## Section 7: Spent Fuel Pool Integrity Evaluation

### 7.1 Scope of the Seismic Evaluation for the SFP

Figure 7-1  
Basic Process for Evaluation of Potential Failures for SFP Penetrations

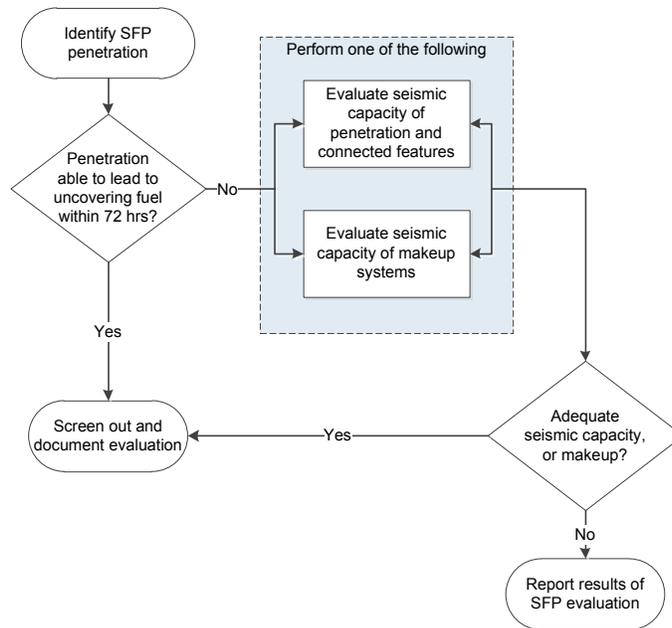
1. Those that are above the level of the fuel in the SFP;
- ~~2. Those that are at a level below the top of the fuel in the SFP; and~~
- ~~2. Those that are above the level of the fuel in the SFP; and~~
3. Those that may have the potential to siphon water from the SFP (most typically, the discharge line from the SFP cooling system).

The sections that follow provide guidance for addressing each of these categories. Figure 7-1 shows the general process for evaluating SFP penetrations.

Figure 7-2  
 Basic Process for Evaluation of Potential Siphoning of SFP Inventory

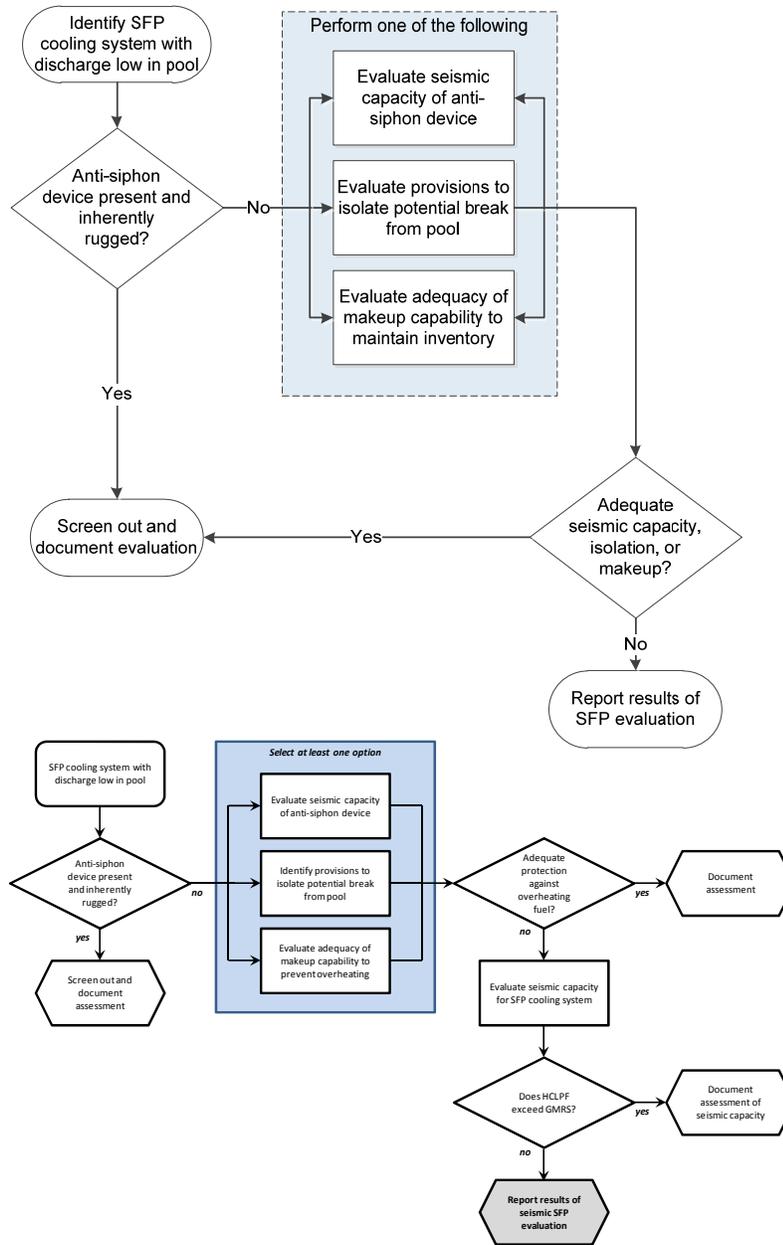
Although designs differ from plant to plant, for some SFPs the discharge line from the SFP cooling system extends down into the pool. Cool water is introduced low in the pool, and the suction line takes warm water from closer to the top of the pool. If the SFP cooling system were to experience a failure, it is possible that water could be siphoned back through the discharge line and out the break. To prevent such an occurrence, SFP cooling systems with this configuration are typically equipped with anti-siphon devices. If the anti-siphon device were to function improperly, the effect ~~could essentially be similar~~ ~~equivalent~~ to a break below the top of the fuel, as addressed in Section 7.2.24. ~~Thus, the process for evaluating failures in the SFP cooling system that might lead to siphoning inventory from the pool is outlined in Figure 7-3.~~

The anti-siphon devices are expected to be relatively rugged; for purposes of this evaluation, an evaluation should be ~~performed~~ ~~made~~ to confirm that, if such a feature is needed to prevent siphoning water from the pool. If there are questions about the ruggedness of the feature, the evaluation may follow one of three paths, depending on what information is most readily available:
